Section 12A Application No. Y/I-DB/2
To Amend Discovery Bay Outline Zoning Plan
For rezoning the permissible use from staff quarters to flats
At Area 6f, Discovery Bay

Response to Comments
October 2016

**Section 12A Application No.Y/I-DB/2
For rezoning the permissible use from staff quarters to flats at Area 6f, Discovery Bay
Response to Comments**

Section 12A Application No.Y/I-DB/2 for rezoning the permissible use from staff quarters to flats at Area 6f
 Applicant's response to the departmental comments made available by District Planning Office on 25 and 28 July 2016

REV. A
 OCTOBER 2016
 FIGURE: **B.2**

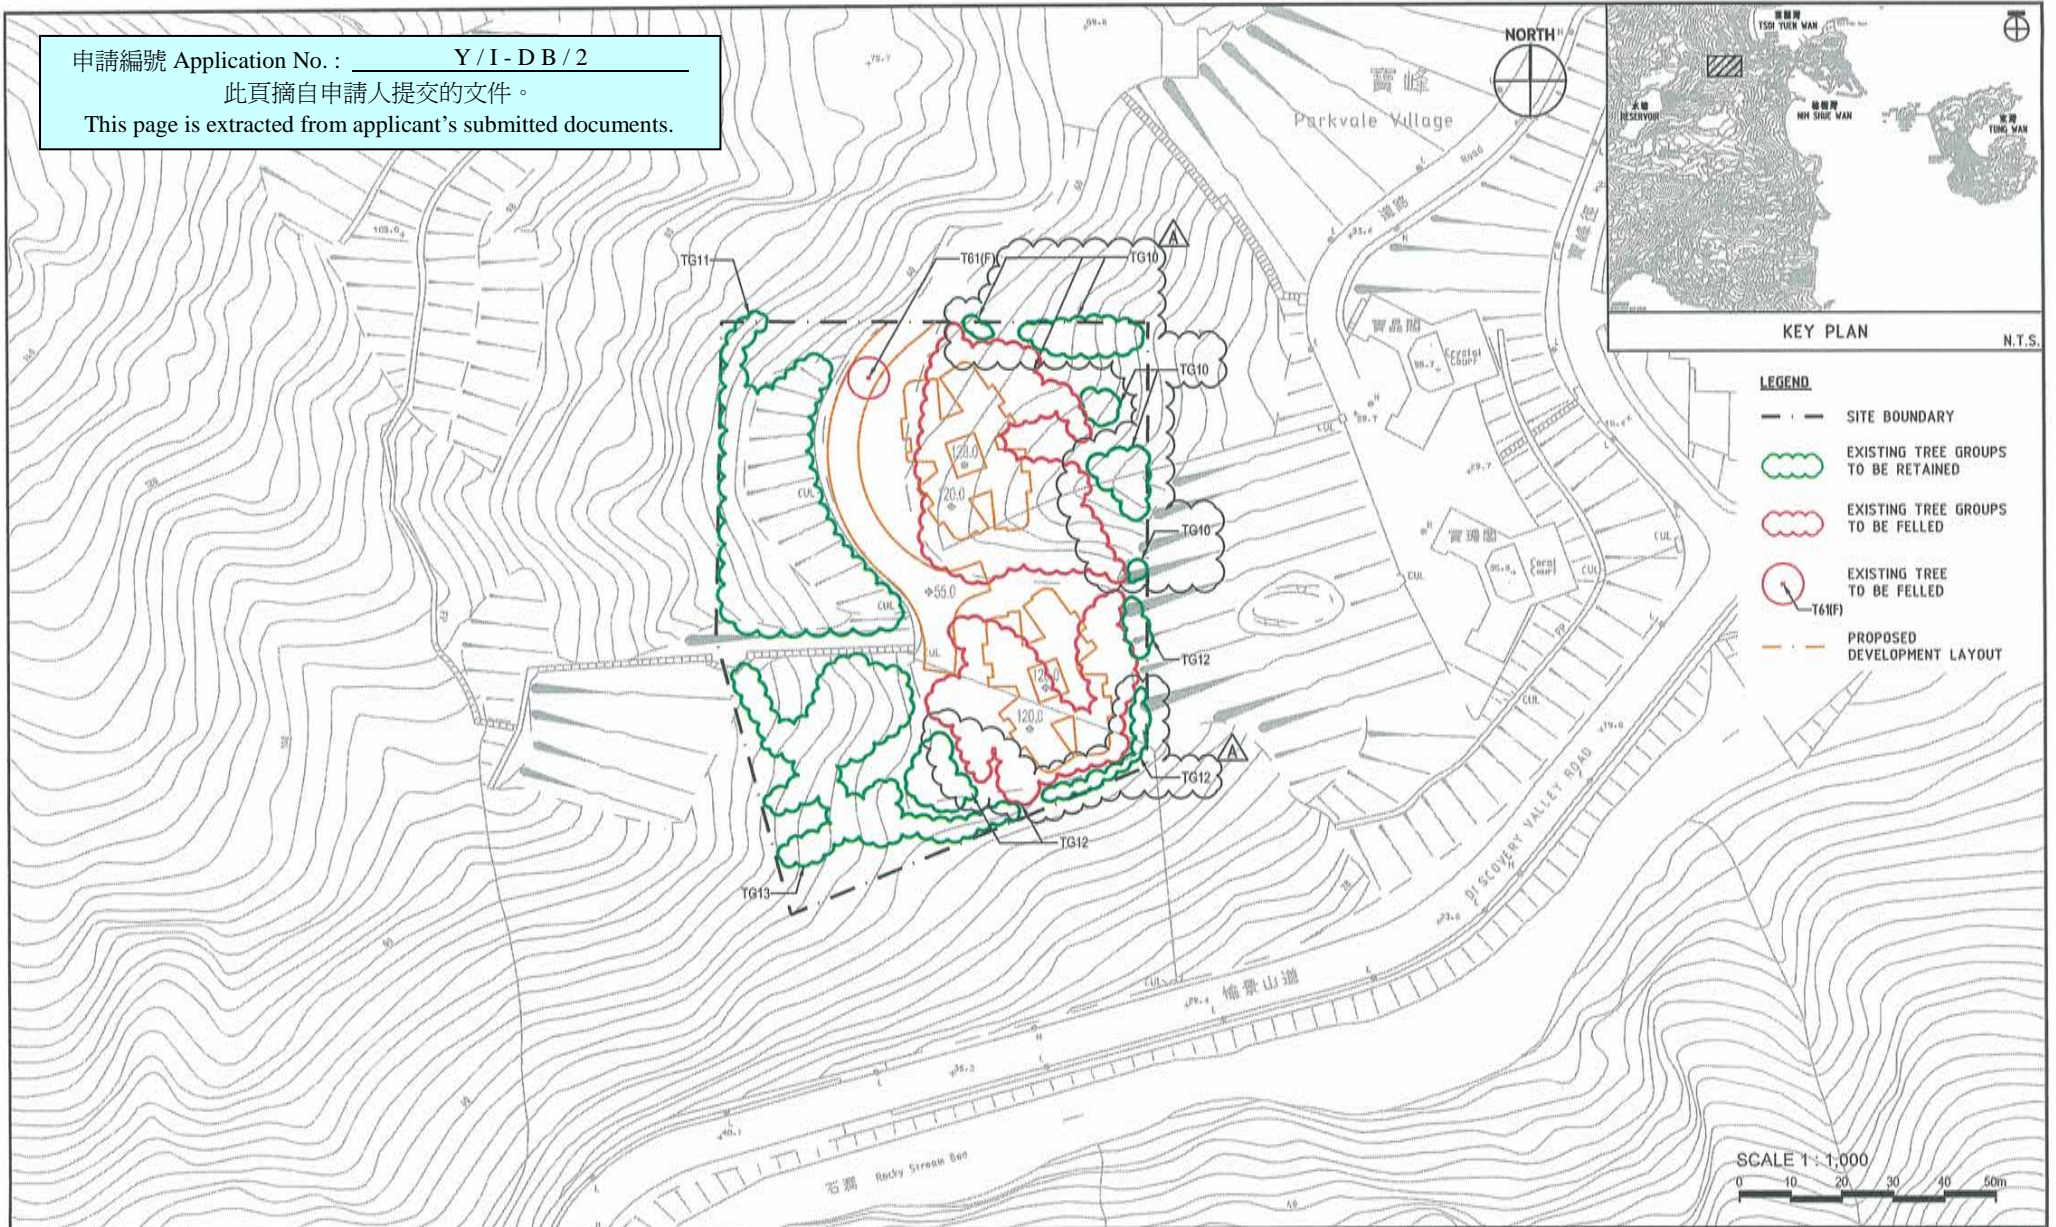
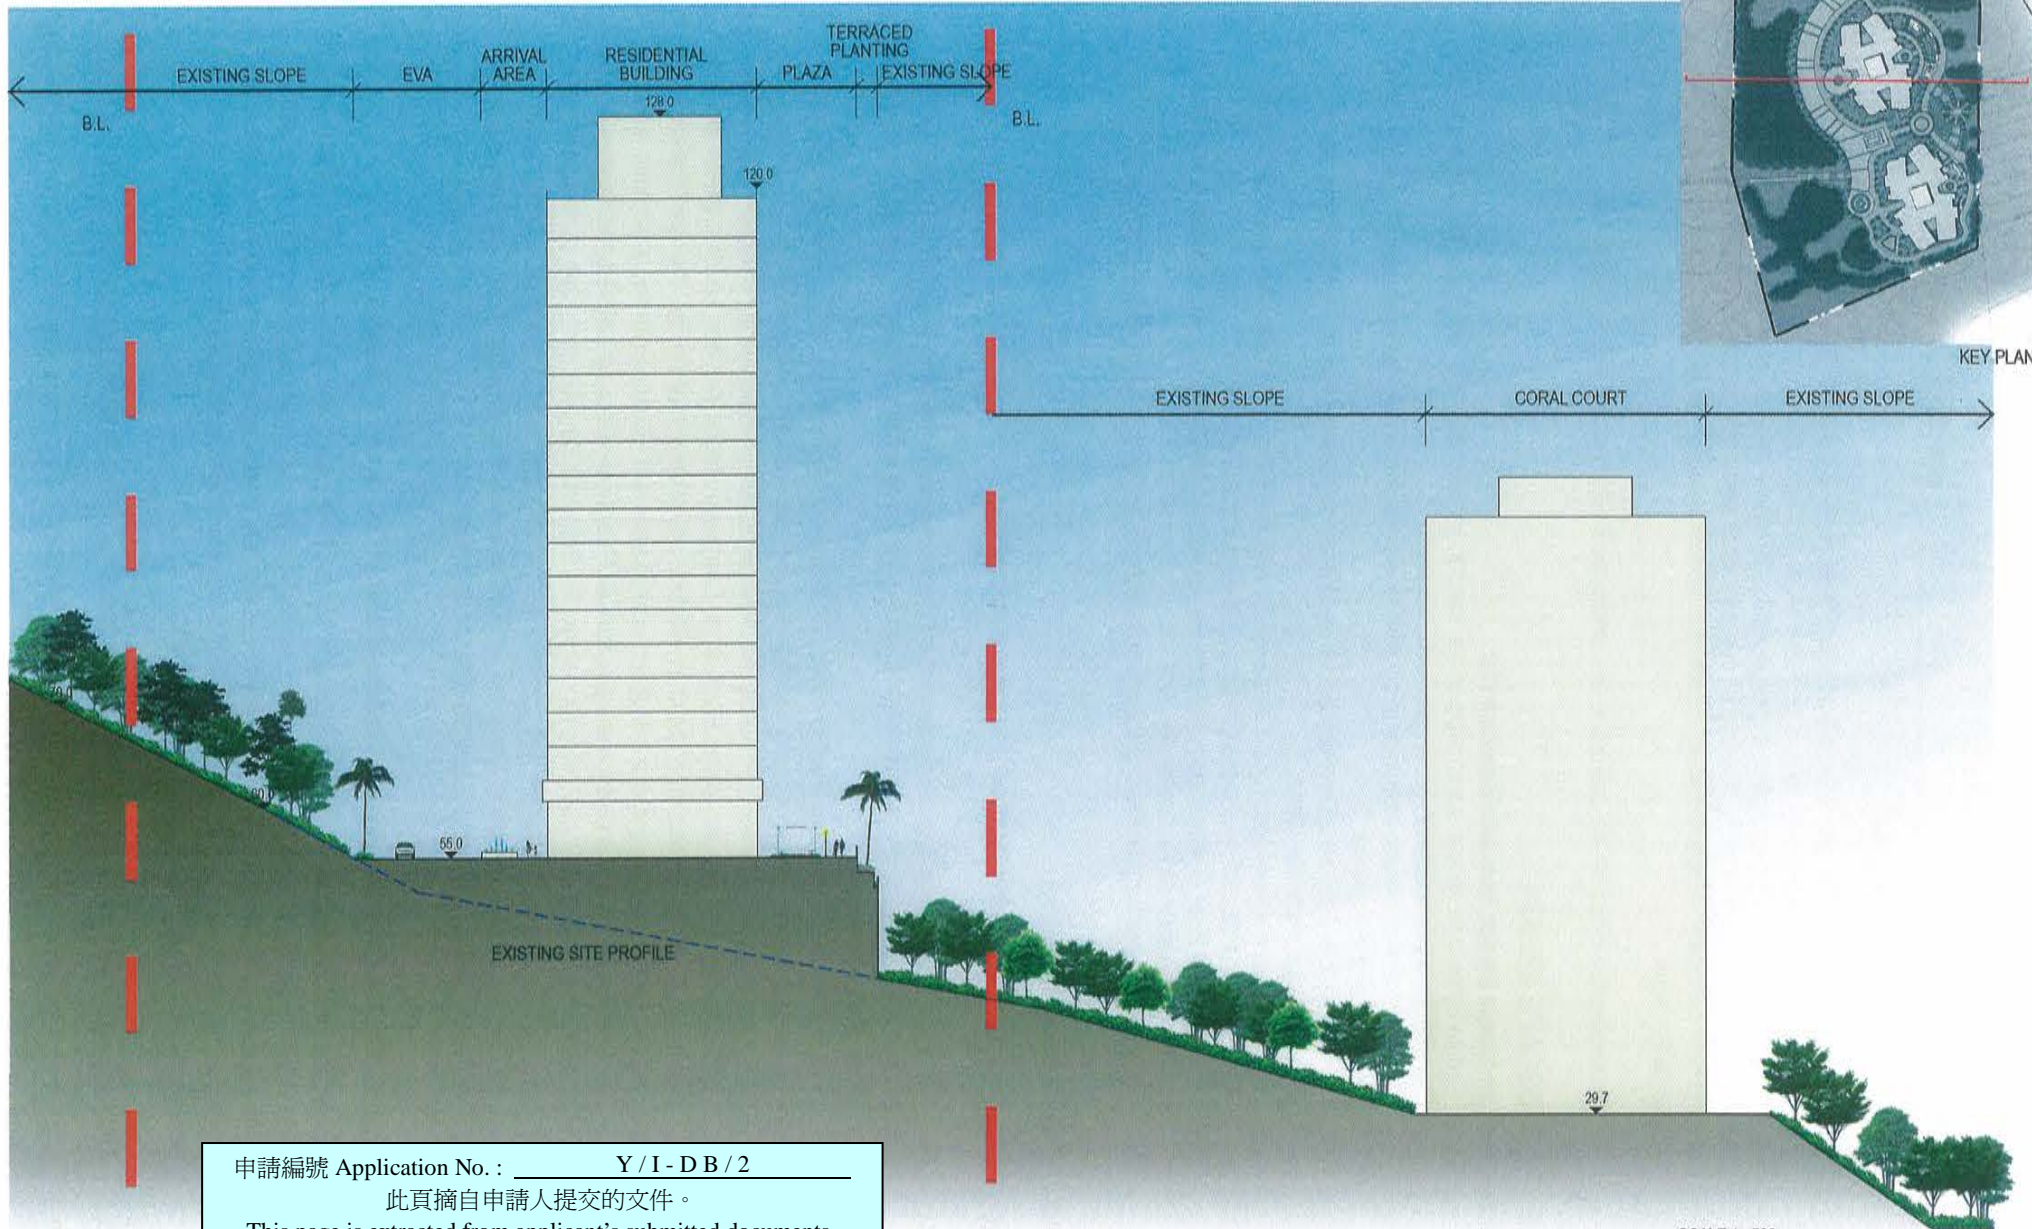
AFCD's comment	Applicant's response
<p>According to the previous submission, 118 numbers of trees are proposed to be felled. It is noted from the FI that an extra 20 trees, i.e. 70 trees in total, would be planted as compensation due to limited planting space on site. The applicant should demonstrate efforts to achieve a 1:1 ratio in quantity of compensatory planting as far as practicable. In any event, the extent of tree felling should first be avoided/minimized as far as possible.</p>	<p>The Concept Plan has been revised to address departmental comments (Annex A).</p> <p>The proposed tree treatments and landscape area layout have also been adjusted as a result. The number of trees to be felled remains the same. The extent of tree felling has already been minimized and only the trees that will be affected by the proposed development footprint, proposed communal open space or construction works are proposed to be felled. However, in the revised Landscape Design Proposal, 148 nos. of compensatory trees will be planted within the proposed development site, as shown in Annex B.</p>

Compensatory trees will consist of heavy-standard trees with a minimum size of 100mm DBH. Total aggregate girth of the 118 existing trees to be felled within this Application Site is 46.40m. To compensate the number of trees felled by equivalent aggregate girth with heavy standard planting would require 148no. trees of 46.47m aggregate girth. 148nos. of compensatory trees will be planted within the proposed development boundary. Please refer to Figure B.1 Landscape Master Plan for the locations of the compensatory trees.

FIGURE 4-1

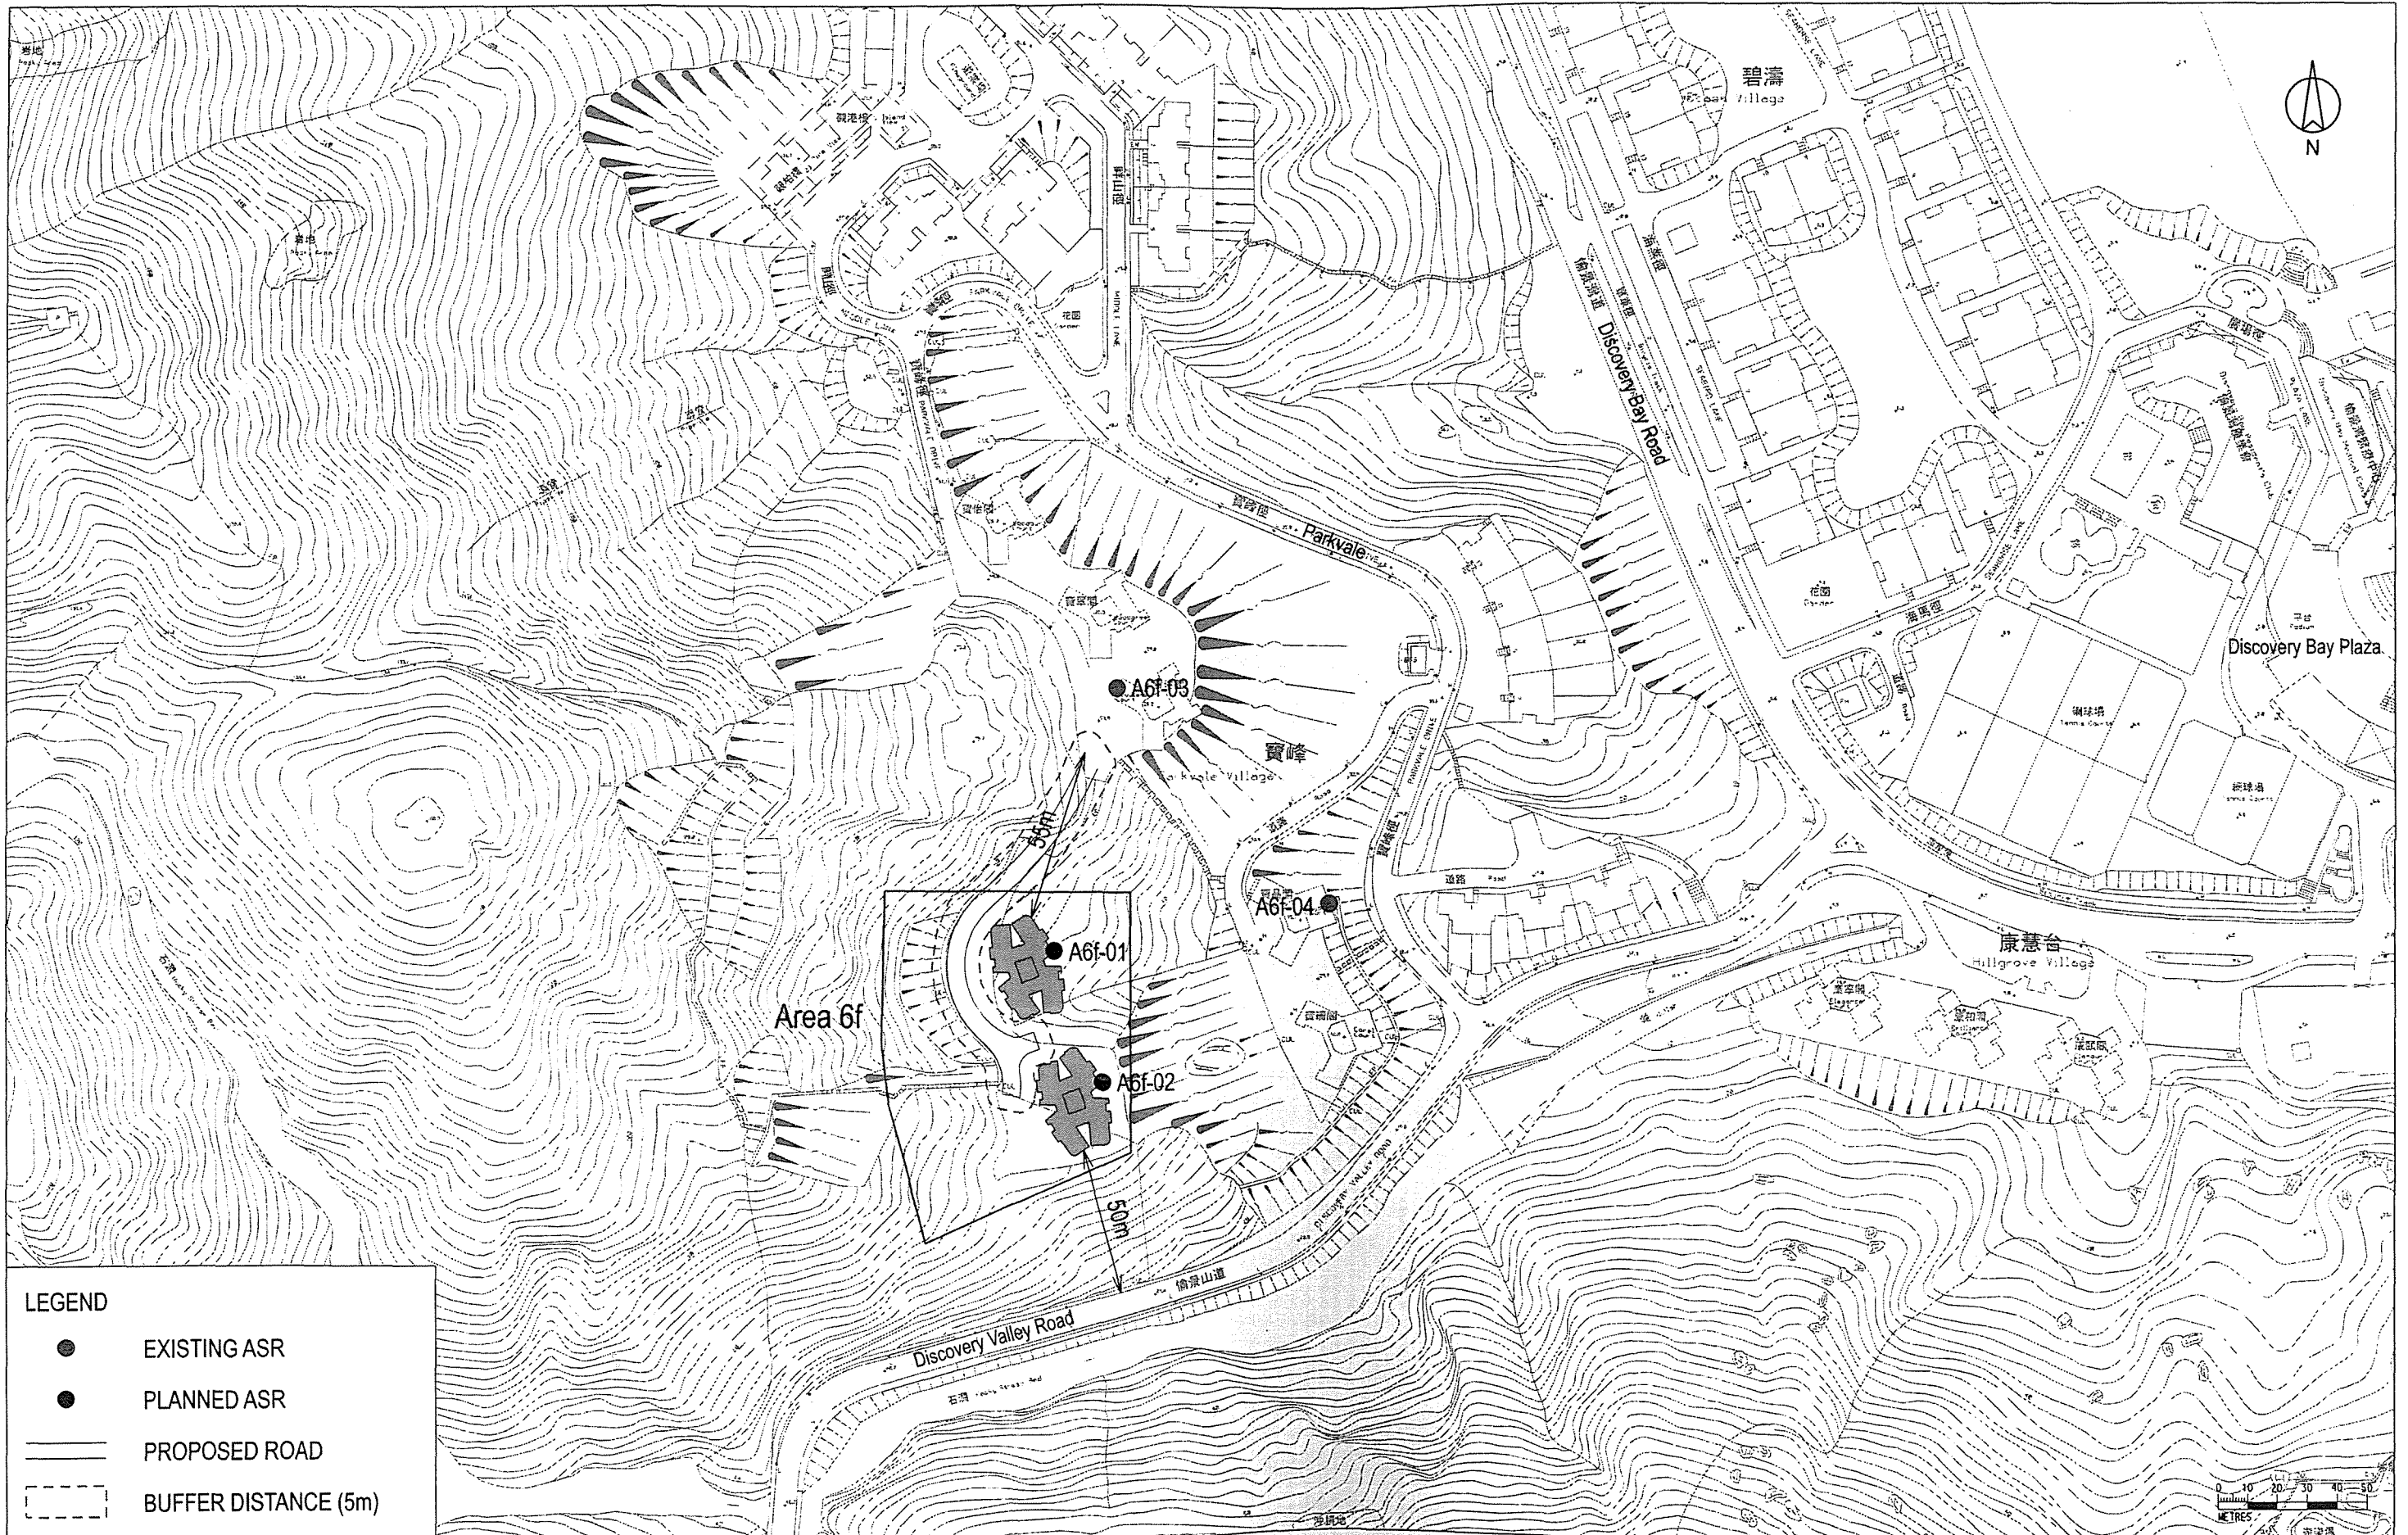
<p>3. <u>Rtc item e</u> Separation distance between ASRs and roads has not been marked on the map.</p>	<p>Noted. The separation distance between ASRs and roads has been provided on Figure 4-1.</p>
<p>4. <u>Figure 4-1</u> Please clarify why there is buffer zone on one side of the road near A6f-01 and A6f-02 but not the other side of the same road.</p>	<p>Noted. The buffer zone has been added to Figure 4-1.</p>
<p>5. <u>Rtc item g</u> Please include the response into the report.</p>	<p>Noted: Section 4.2.3.1 has been updated as follows.</p> <p><i>"...Site surveys conducted in May and June 2014 revealed that there is no existing chimney within 500m assessment area. In consideration of there is no change of the existing environment and no major development within 500m assessment area, the finding of the site visits in 2014 are still considered valid. As such, it is concluded that no cumulative air quality impact from industrial emission is anticipated..."</i></p>

<p>8. <u>S4.2.2.2 and S4.2.2.3</u> Please clarify how the separation distance is measured (e.g. 45m, 80m, etc.).</p>	<p>The separation distance has been shown in the Figure 4-1.</p>
<p>9. Regarding the calculation spreadsheet, the calculation of max. 8-hr RSP, which <u>subsequently</u> be used for heavy metal impact estimation from fireworks, was calculated as 1/8 of max. 1-hr RSP output from ISC model. Please clarify and provide justifications for adopting such method instead of using running average of 8 1-hr concentrations.</p>	<p>Since there is only 1 firework show last for less than 60 minutes per day, the heavy metal contribution of firework will be equal to 0 for other 23 hours. In addition, it is either 1 show or no show every 8 hour running period. Therefore, the maximum running 8 hour average will be equal to maximum 1 hour divided by 8.</p> <p>For example, assume the maximum contribution from firework = x_n, where n is the hour for firework display. As the firework show is started at 8pm, there are no shown before or after 7 hour of the show.</p> <p>Therefore, the maximum running 8-hour average</p> $= \sum_{n=1}^8 \frac{x_n}{8}$ $= \frac{(x+0+0+0+0+0+0+0)}{8}$ $= \frac{x}{8}$
